ALLRISE

COMMENTS ON THE PROPOSED JINDAL MELMOTH IRON ORE PROJECT & COMMENTS ON THE DRAFT ENVIRONMENTAL IMPACT ASSESSMENT REPORT ("EIAR") AND ENVIRONMENTAL MANAGEMENT PROGRAMME (EMPr) ("the Application") - DMRE KZN 30/5/1/2/2/10108MR

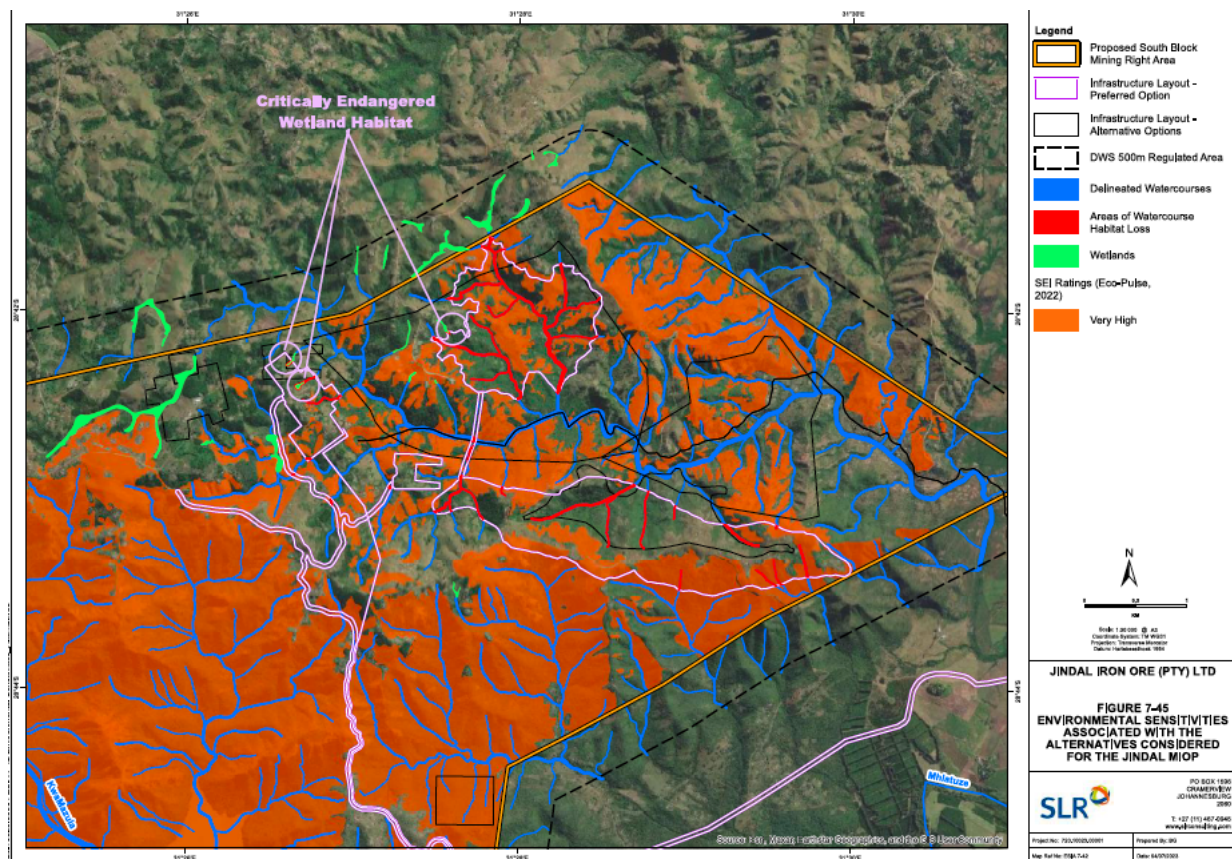
55. The processing plant and the primary crusher footprint coincide with open savannah/grassland areas (Vegetation Community 1) rated as being of Very High SEI which is part of the recommended terrestrial no-go Area. Without re-siting, the above-

mentioned vegetation community stands to be directly or indirectly impacted by the proposed infrastructure. The proposed processing plant location also coincides with the headwater areas of two Mountain Headwater Streams, a single wetland, and a single Mountain Stream. Additionally, the proposed location of the incoming power yard coincides with a single wetland while the primary crusher advances into the preliminarily recommended watercourse buffer zone area for a Mountain Headwater Stream and a Mountain Stream. According the EIAR, there is limited scope for alternate sites due to the topography of the area which required that terraces be built for the processing plant and substation and suitable space for this size of infrastructure is limited. [Our emphasis]
